WORK INSPECTION REQUEST (WIR) FORM

Contractor:	HAIF-FREYSSINET JV
Project:	RA2RC
Contract No.:	QPMO-410-CT-00618
Work Inspection Request Number:	QRXM114000-HFC-TEC-WIR-ITS-02-RO5-00047

Inspection request for Installing ITS Red Light Camera 6.1m.Pole With Accessories (4 Pcs.) Junction-1 at Access to Resort core interim Road. As per attached drawing.

SHOPDRAWING OF TRAFFIC SIGNAL SYSTEM FOR JUNCTION-1

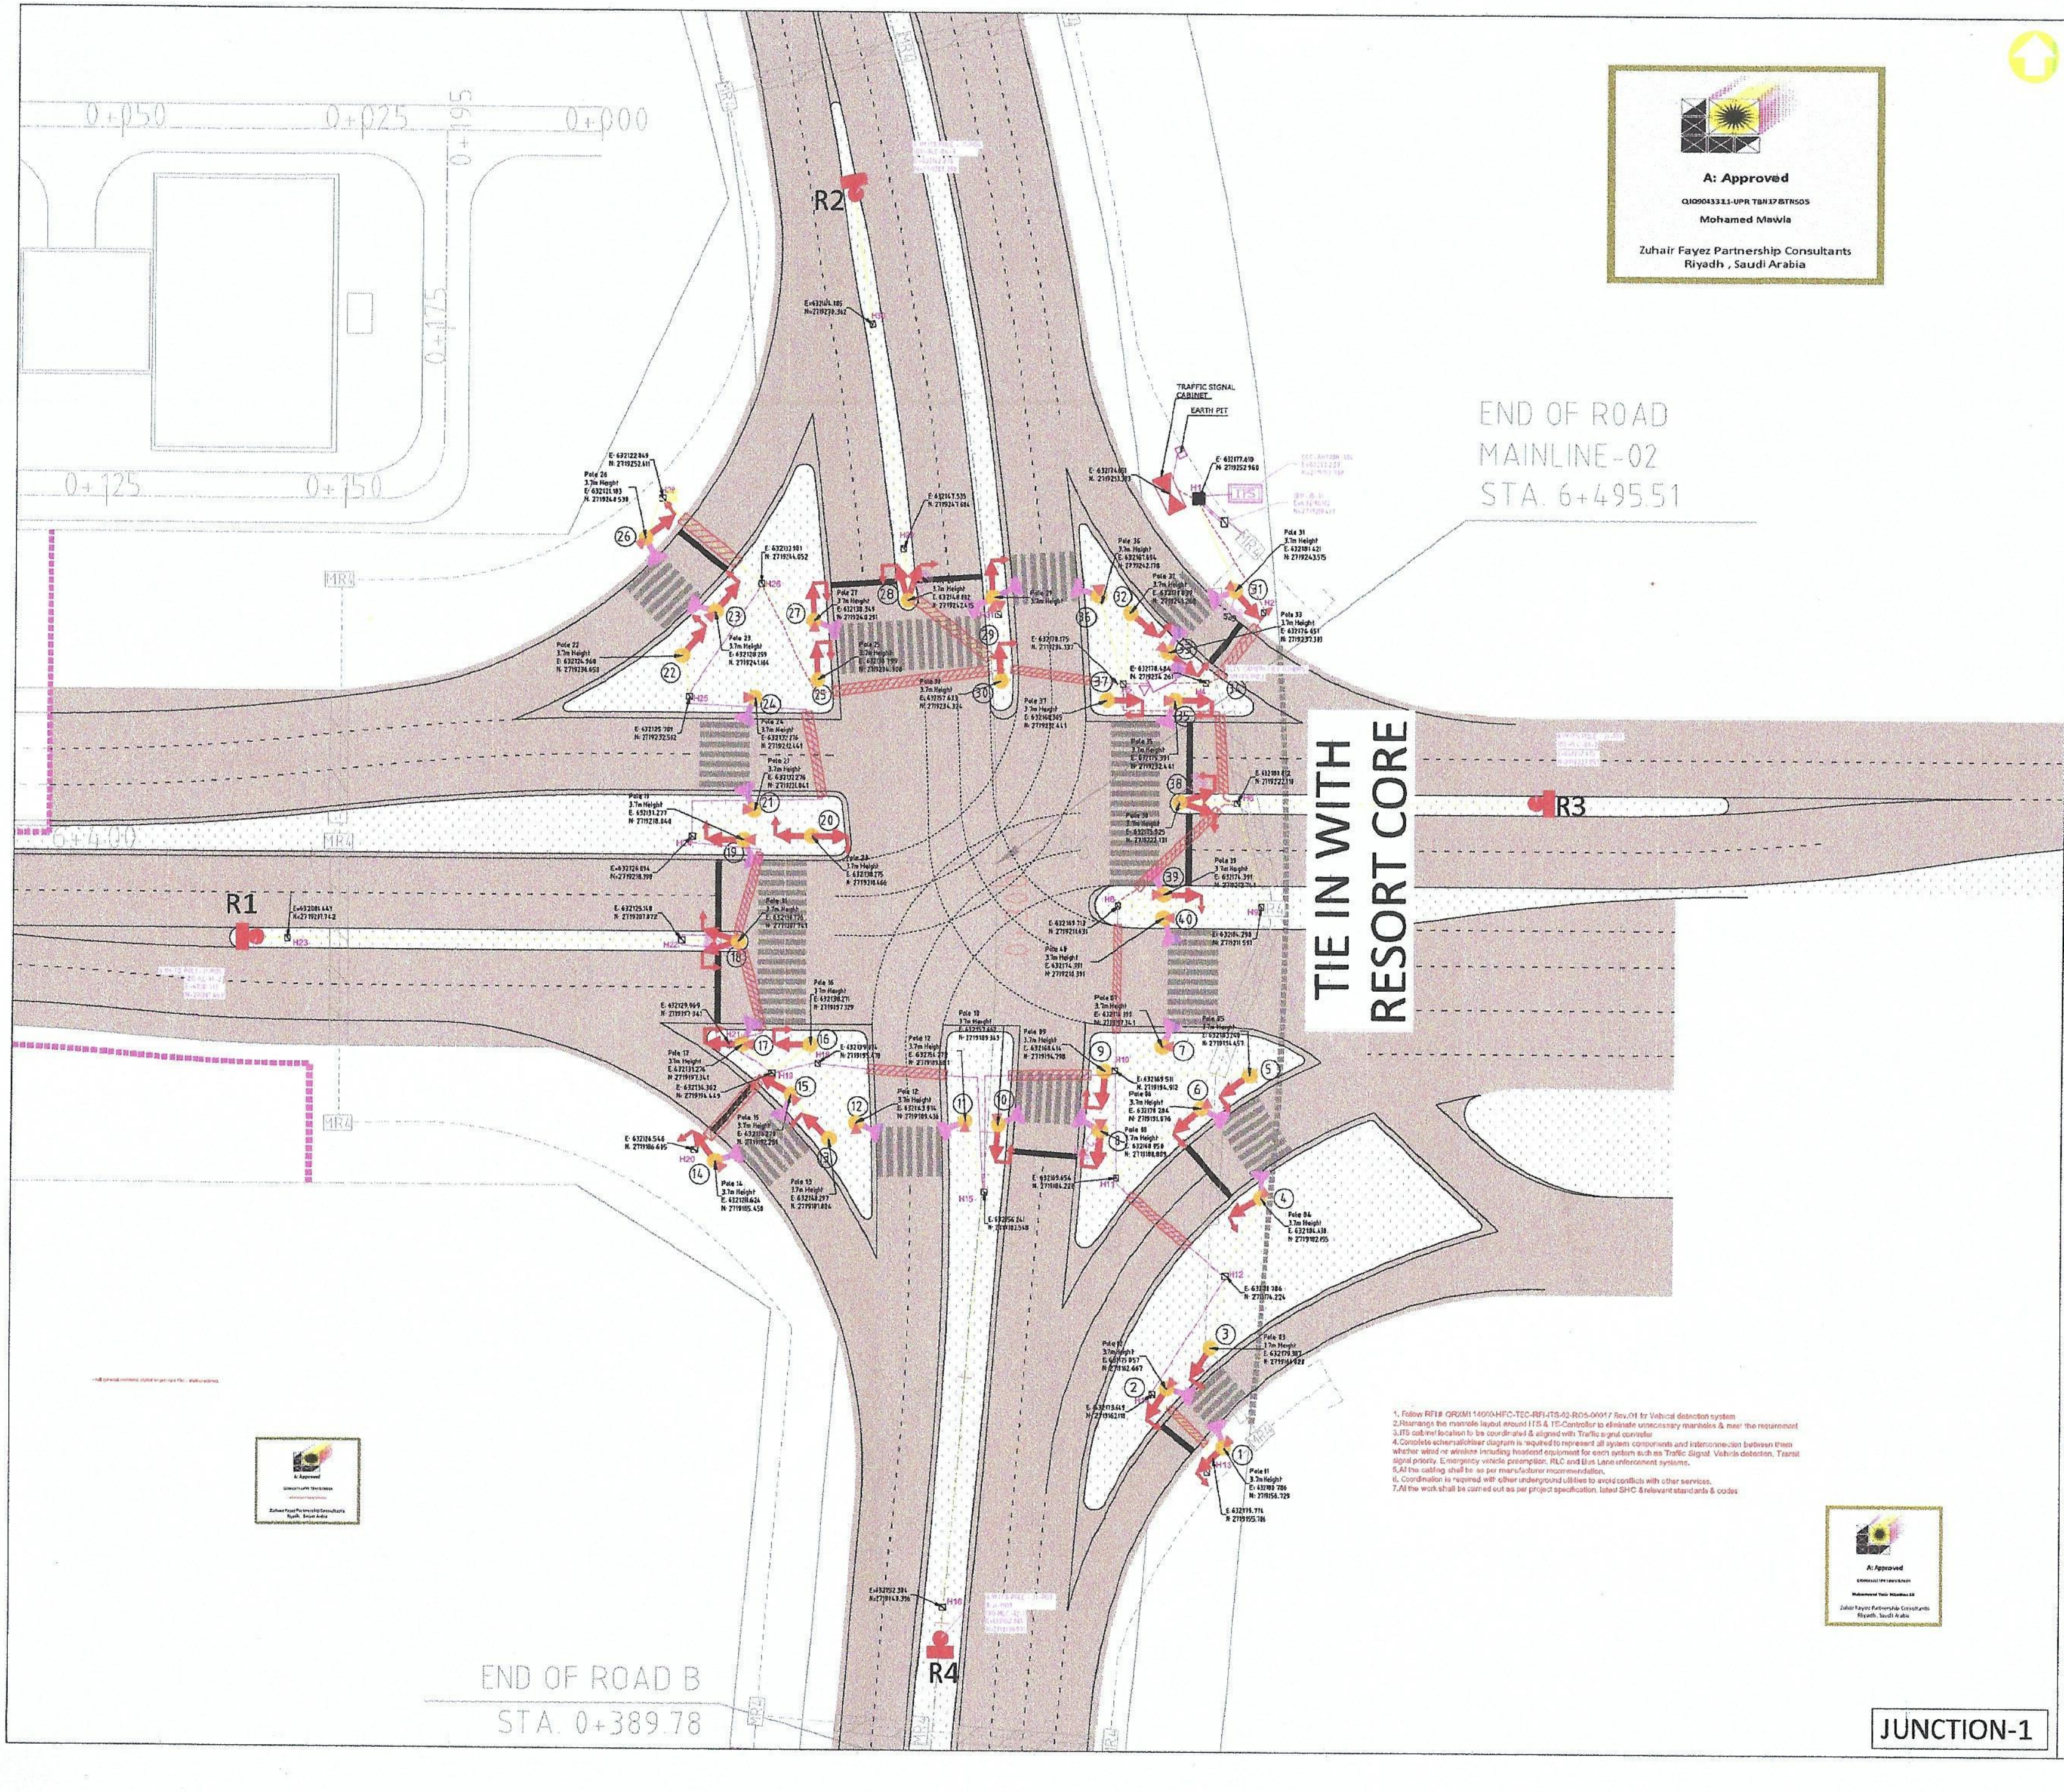
1. Follow RFI# QRXM114000-HFC-TEC-RFI-ITS-02-RO5-00017 Rev.01 for Vehical detection system
2. Rearrange the manhole layout around ITS & TS-Controller to eliminate unnecessary manholes & meet the requirement
3. ITS cabinet location to be coordinated & aligned with Traffic signal controller
4. Complete schematic/riser diagram is required to represent all system components and interconnection between them whether wired or wireless including headend equipment for each system such as Traffic Signal, Vehicle detection, Transit signal priority, Emergency vehicle preemption, RLC and Bus Lane enforcement systems.
5. All the cabling shall be as per manufacturer recommendation.
6. Coordination is required with other underground utilities to avoid conflicts with other services.
7. All the work shall be carried out as per project specification, latest SHC & relevant standards & codes
